Land at Cranesfield, Sherborne St John, Basingstoke

Hampshire County Council Comments Response Technical Note

Document Reference: WIE18375.105.R.5.1.3.TN2 - Rebuttal

- 1.3. The purpose of this Technical Note is to respond to the further comments received from HCC Highways Development Planning, dated 2nd January 2026 (document ref: 058797), appended in full to this note.

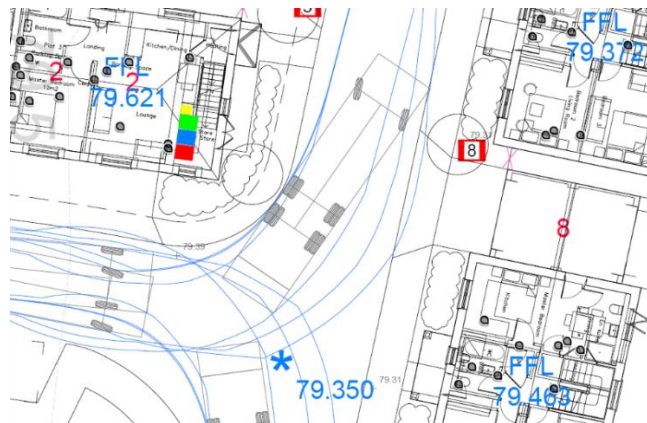
In order to ensure a safe pedestrian layout and be suitable for adoption, a footway would be required on the frontage to plots 1, 2, 3 and 5, as well as

any other areas where pedestrians would be expected to walk on the lengths of road likely to be offered for adoption.

'In order to ensure a safe pedestrian layout and be suitable for adoption, a footway would be required on the frontage to plots 1, 2, 3 and 5, as well as any other areas where pedestrians would be expected to walk on the lengths of road likely to be offered for adoption.'

- 2.4. Given the low vehicle speeds and low traffic proposals, it is considered that a shared surface arrangement, with formal footway provision on one side of the carriageway, is suitable to accommodate the expected level of pedestrian movements without conflict with vehicle movements within the site.
- 2.5. However, as above, 2.0m footway connections are demonstrated on amended layout plan.

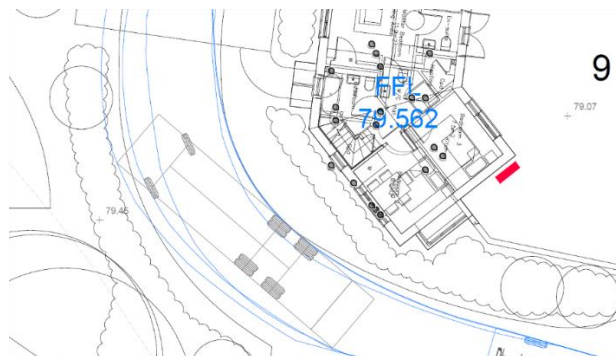
The manoeuvre overhangs the footway adjacent to plot 8:

- 2.12. The refuse collection manoeuvre described above (and identified in the image included within the HCC comments) is not considered out of the ordinary, with refuse vehicles often overhanging the edge of carriageway when making manoeuvres but the wheels remain within the extent of the carriageway when safe to do so.
- 2.13. Given that refuse collection with a vehicle of that scale occurs once per week, the resulting potential for safety issues and conflict is limited.

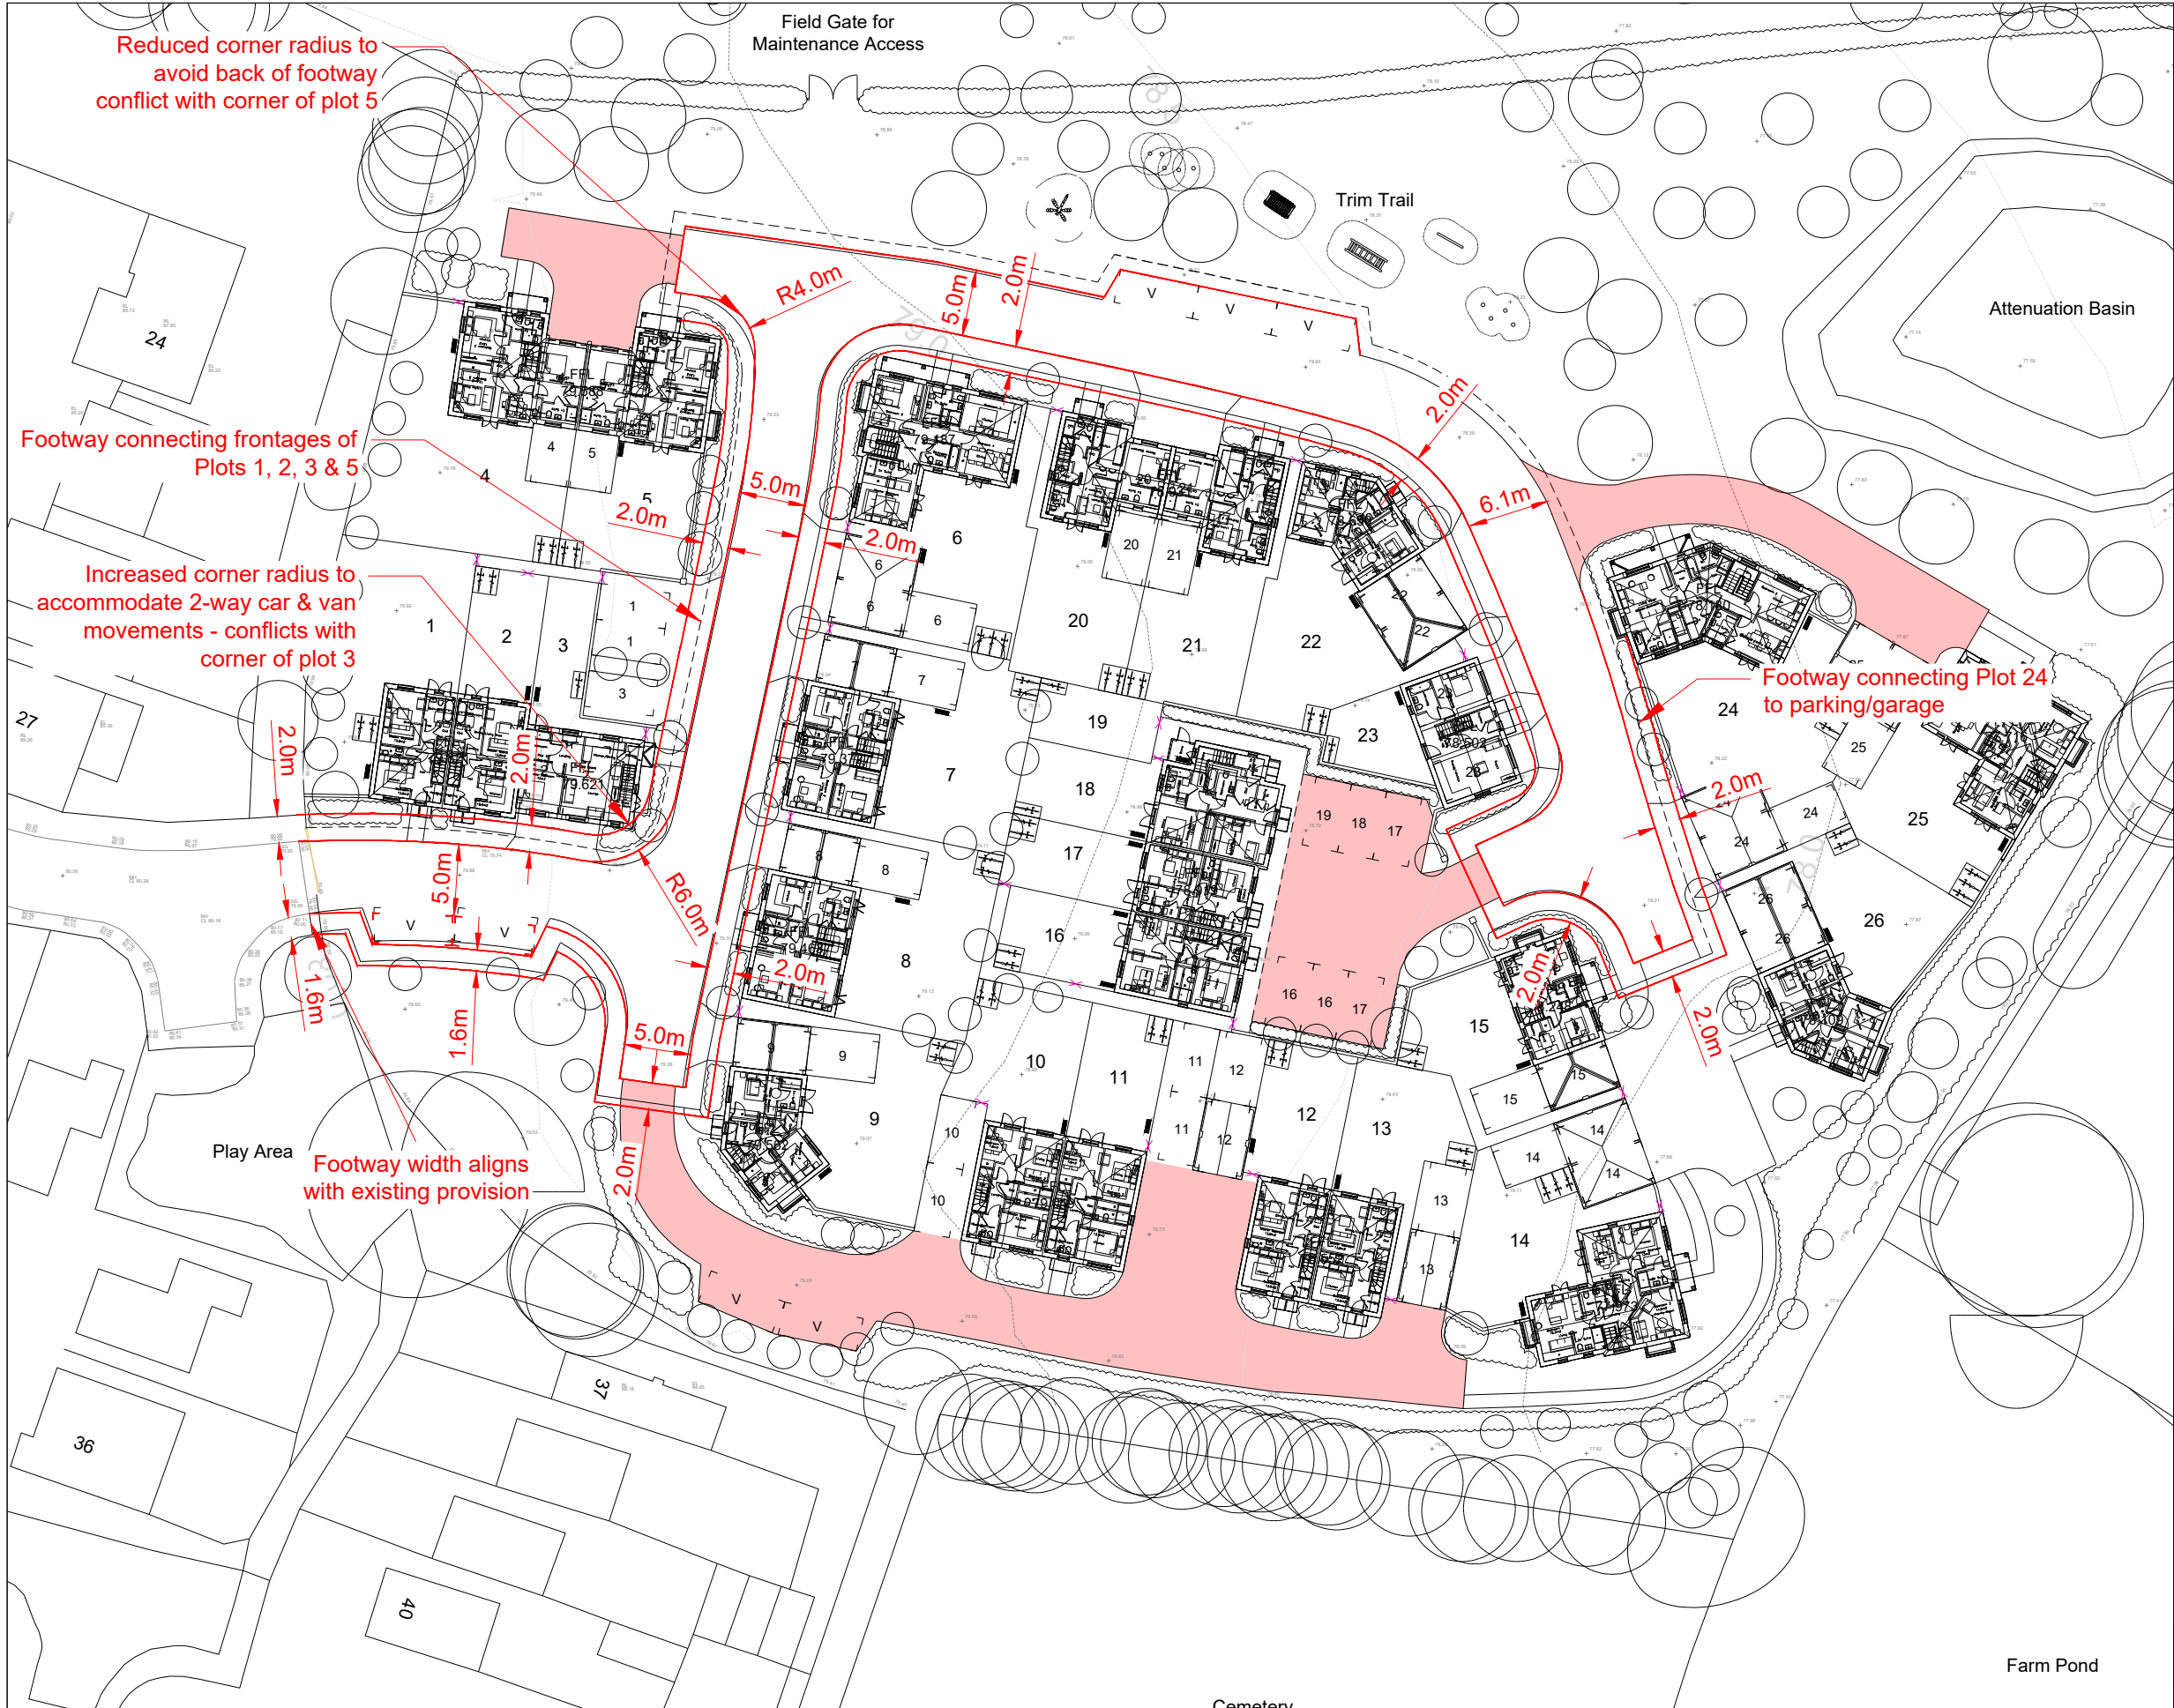
The swept path adjacent to the plot 9 suggests the carriageway is not wide enough to accommodate the refuse vehicle manoeuvre:

The refuse vehicle turning manoeuvre should be contained within the carriageway at the turning head:

The refuse vehicle would take up the majority of the carriageway and there is limited space to allow a car to wait whilst a refuse vehicle passes.

- 2.14. This location adjacent to plot 9 is a shared surface area, where the edge of carriageway indicatively shown only, with the entire area available to accommodate the vehicle movements (excluding areas of planting/landscaping).

- 2.15. Again, the refuse collection manoeuvre described above (and identified in the images included within the HCC comments) is not considered out of the ordinary. The frequency of the collection movements limits the potential for safety issues and conflict as a result of the refuse vehicle accessing the development site.
- 2.16. However, the adjustments to the geometries identified on the amended layout plan accommodates the movements at the turning head and adjacent to plot 8 with limited (or without) the vehicle body overhanging the edge of carriageway.

Proposed Layout
Visibility

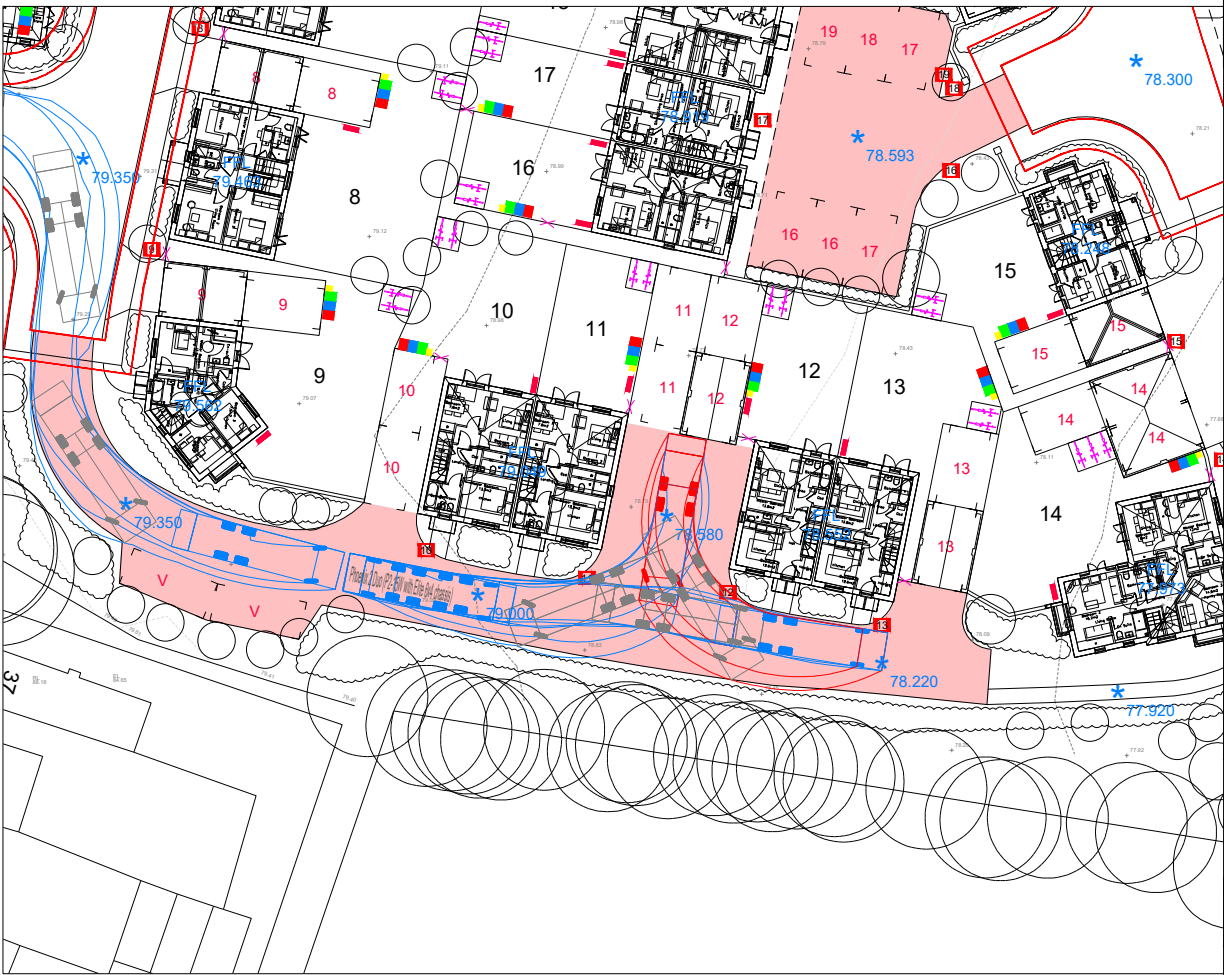
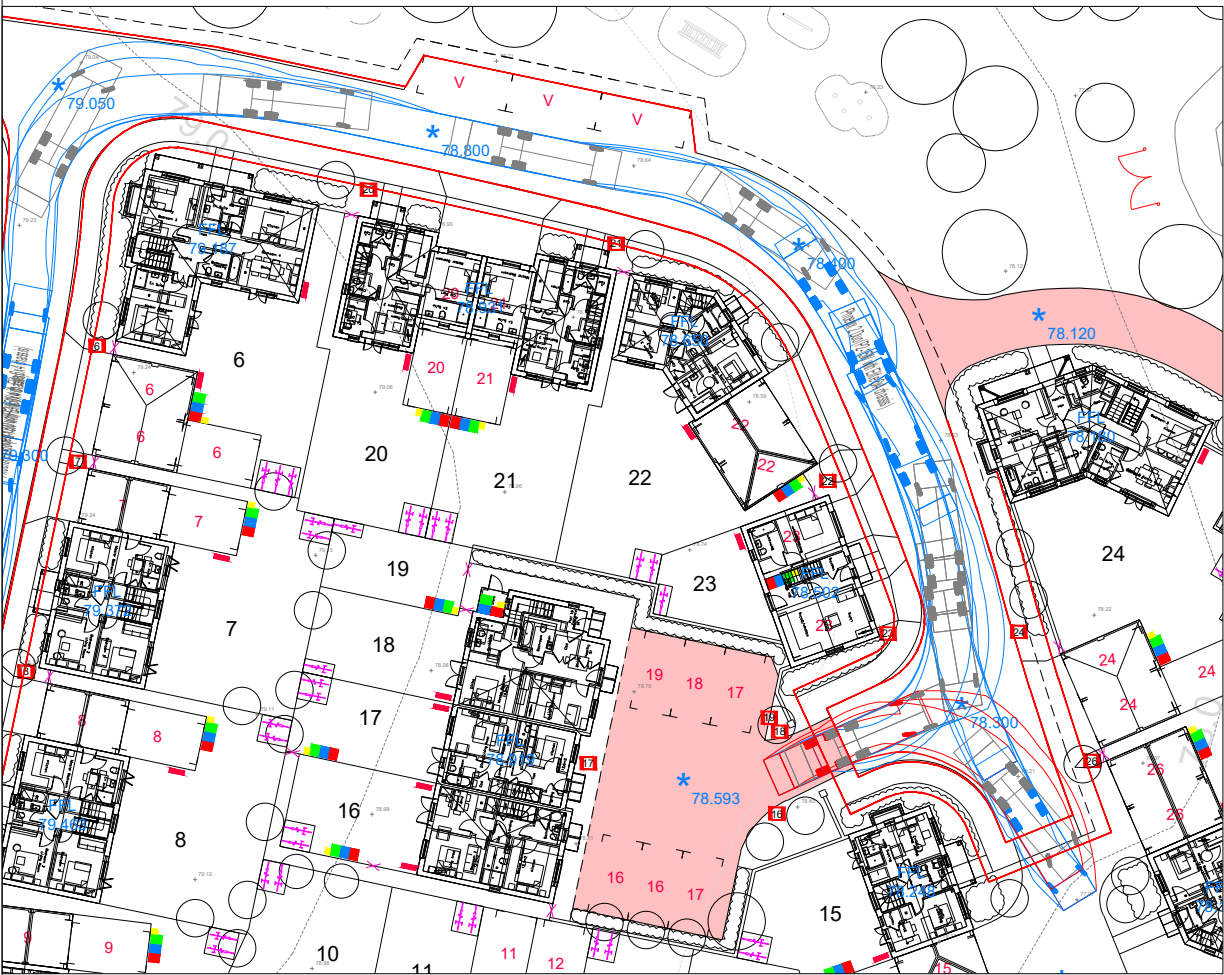
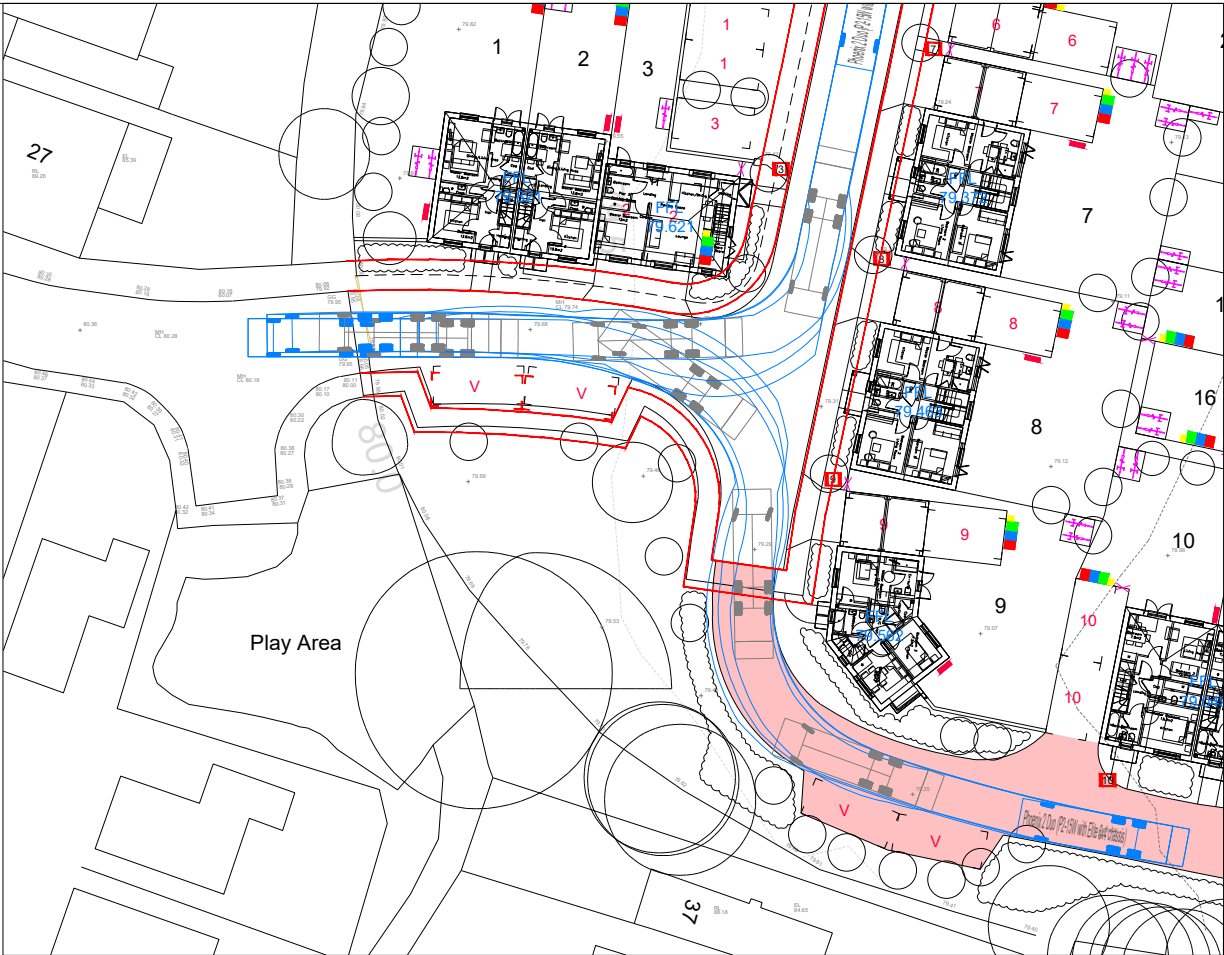
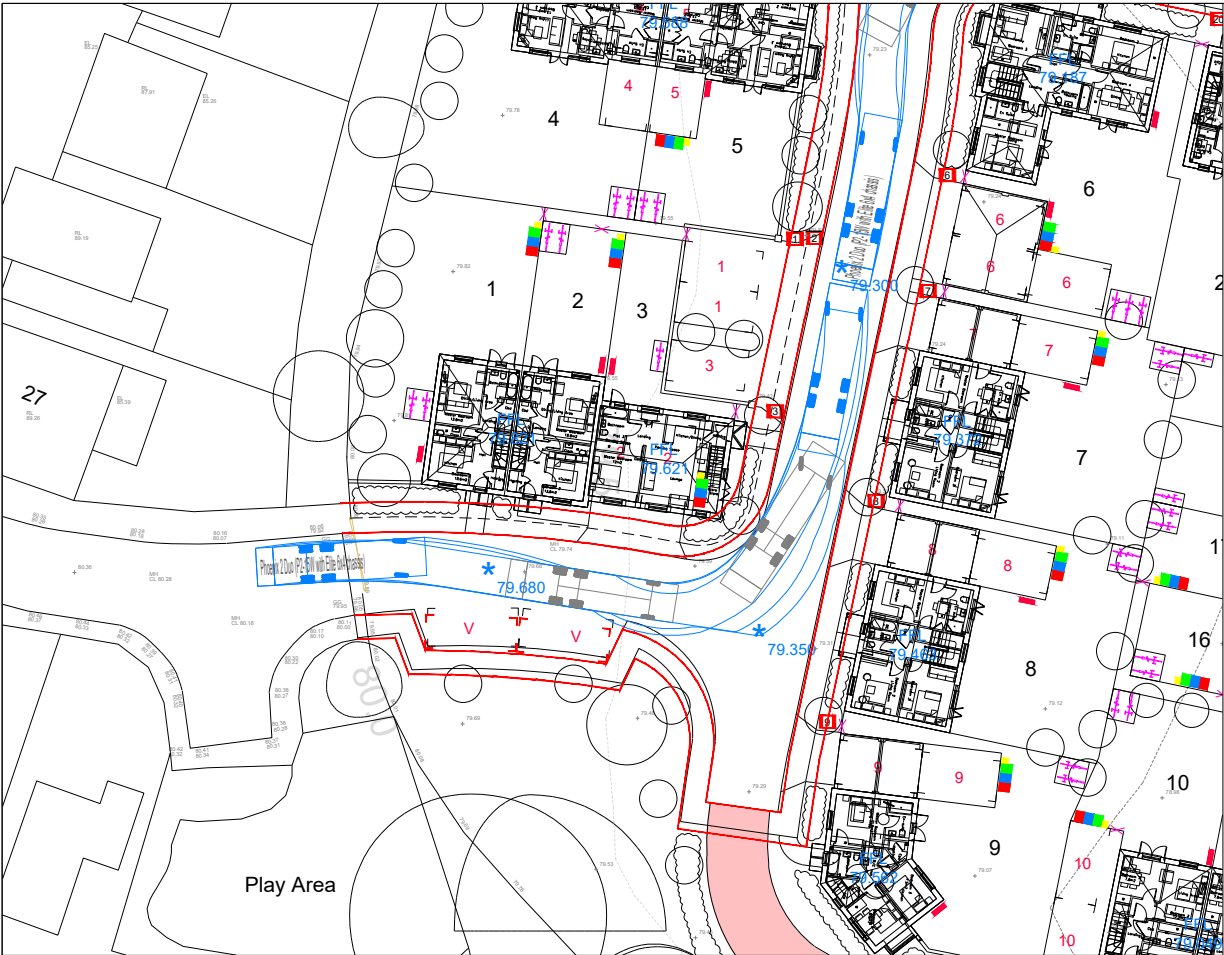
The visibility splays are based on a 10mph, however HCC require these to be based on a 15mph speed for a tertiary street.

- 2.7. However, for completeness and to align with HCC's request, 17m visibility distances (MfS requirement for 15mph speeds) for both forward visibility and junction visibility splays are shown on the revised visibility plan appended to this note.

17m Forward Visibility (15mph Vehicle Speeds MfS SSD)

2m x 17m Junction Visibility (15mph Vehicle Speeds MfS SSD)
